MFN 06-159 Supplement 1

Subject: **Response to Portion of NRC Request for Additional Information
Letter No. 18 - Related to ESBWR Design Certification Application -
Containment Subcompartment Loads - RAI Numbers 6.2-15 S01,
6.2-18 S01, and 6.2-23 S01**

1. MFN 06-159 Supplement 1 - Response to Portion of NRC Request for Additional Information Letter No. 18 - Related to ESBWR Design Certification Application - Containment Subcompartment Loads - RAI Numbers 6.2-15 S01, 6.2-18 S01, and 6.2-23 S01

Figure 2. Upper Drywell

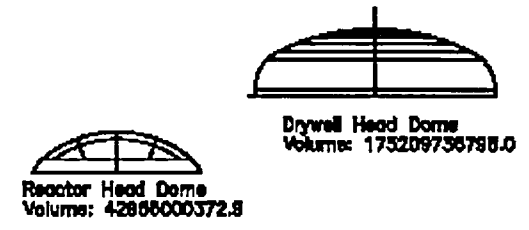
- 2. A description of the upper and lower heads of the reactor vessel.*
 - 3. A description of the shield wall including inner diameter and the volumes surrounding the upper and lower vessel heads.*

- 6. A description of the flow connections (i.e., flow area and flow resistance) between the reactor vessel/shield wall annulus and the upper part of the drywell.*

1. The outer diameter of the reactor vessel is 7.476 meters.
2. Descriptions of the reactor vessel, including upper and lower reactor pressure vessel (RPV) heads, are provided in DCD Tier 2, Revision 3, Subsection 5.3.3.2.1.
3. The geometry of the reactor shield wall (RSW) is shown in the attached Figure (Upper Drywell). The inner diameter of the RSW is 9.292 meters. The thickness is 0.016 meter.
4. A description of RPV insulation is provided in DCD Tier 2, Revision 3, Subsection 5.3.3.2.2, under the heading "Reactor Vessel Insulation." The insulation is designed to remain in place and resist damage during a safe shutdown earthquake. The reactor insulation is not modeled in the annulus pressurization analysis.

6. The geometry of upper drywell head is shown in DCD Tier 2, Revision 3, Figure 3G.1-51. The flow paths between the drywell head and RSW are shown in the attached Figure. The upper drywell head volume is not credited in the annulus pressurization calculation to maximize the annulus pressure.
